From: (e)Transport Development Control Floor 1 North Rear Civic Offices Bridge Street Reading RG1 2LU
To: Jonathan Markwell Jonathan.Markwell@reading.gov.uk
Date: 19th March 2021
Re: Consultation on Planning Application

Application Number: 200188

Address: 55 Vastern Road Reading RG1 8BU

Proposal: Demolition of existing structures and erection of a series of buildings ranging in height from 1 to 11 storeys, including residential dwellings (C3 use class) and retail floorspace (A3 use class), together with a new north-south pedestrian link, connecting Christchurch Bridge to Vastern Road

Figure 5.3: Station/River Major Opportunity Area Strategy

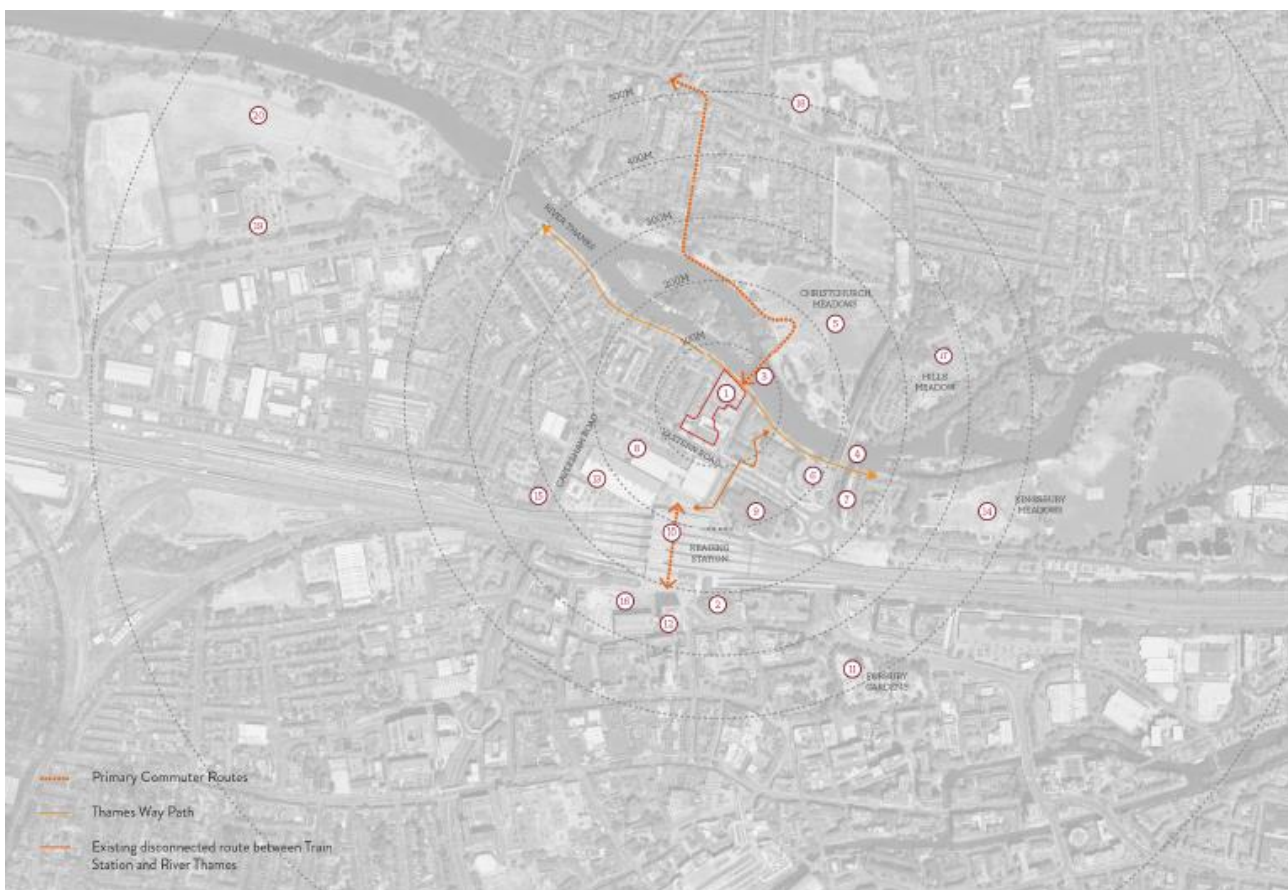
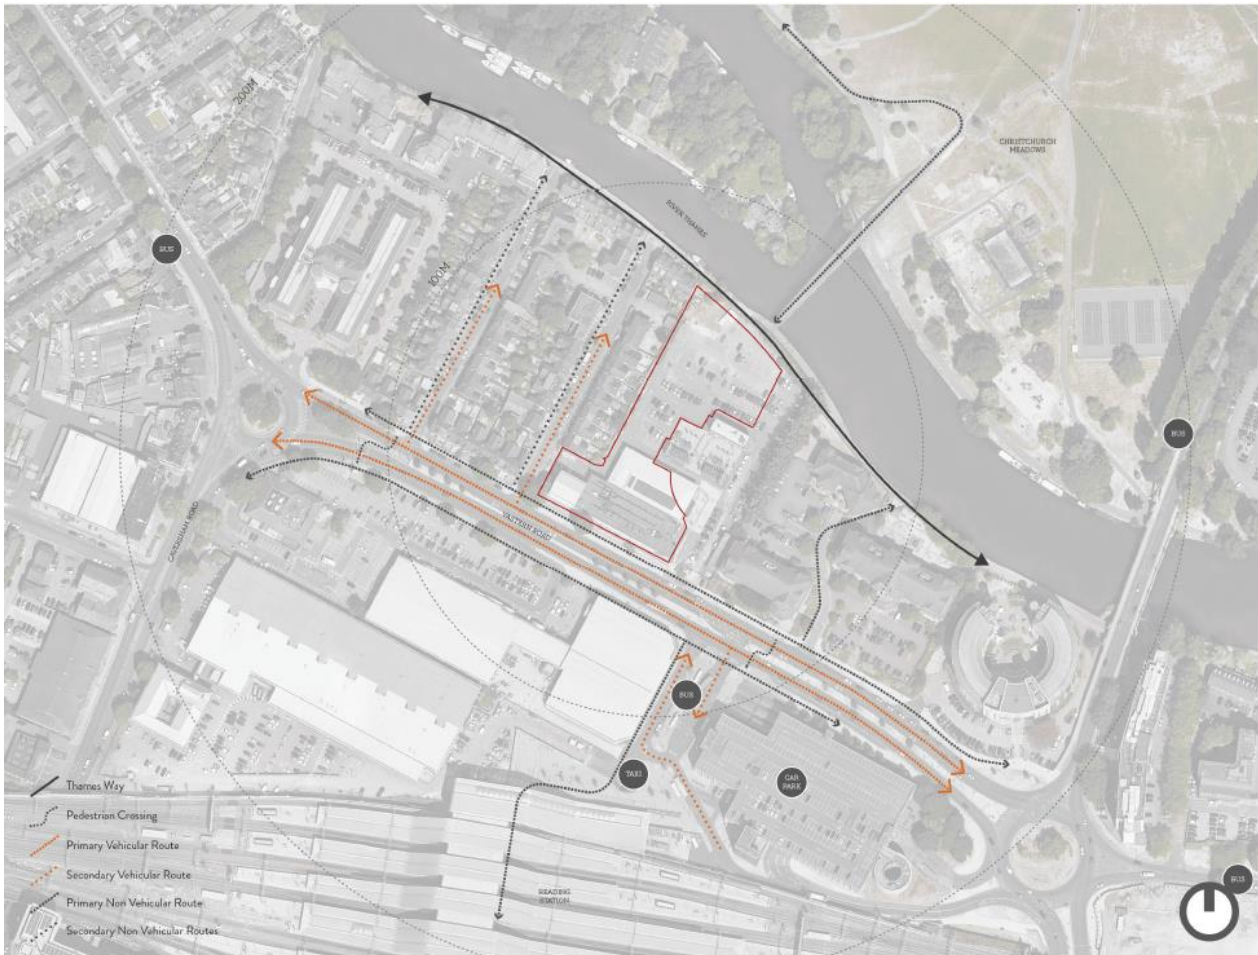
It is therefore clear from Figure 5.3 and Paragraph 5.4.6 from the Local Plan (both above) that an acceptable design of the north south route through the site is fundamental to any development of the site.

However, it is clear that the proposed scheme does not provide a direct pedestrian cycle route as has been requested during the pre-application discussions. This is to ensure that the route is as clear, legible and as convenient as possible. I reference the two images below from the Design and Access Statement which in themselves highlight the importance of the route through the site.

Access and Movement

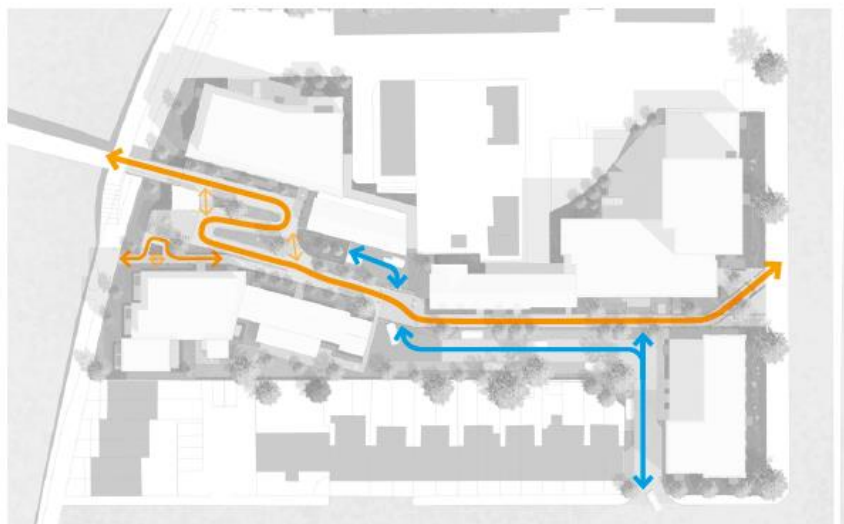
The Technical Note also contradicts the applicants Strategic Shared Cycle Footway document as it stipulates the route to the Towpath as being for cycles, I attach an extract below of the document identifying this, for ease of reference.

On reviewing the latest drawing within the Technical Note it is noted that the section of ramp that has a gradient of 1:21 would be within the maximum length specified in the table above. The revised drawings have however indicated that the gradient to the south of this particular link would be at a gradient of 1:14 approx. instead of the 1:21 previously illustrated. Given that the route should accommodate cyclists a gradient of 1:14 cannot be accepted. In response to the gradient of 1:14 Section 3.2 of DfT document Inclusive Mobility states the following:

Although lesser gradients are accepted within Inclusive Mobility this is a comprehensive redevelopment of the site and not alterations to an existing development where there is less scope to alter levels, therefore the gradient of 1:21 should be adhered to throughout the site and should not extend further than the specified lengths.
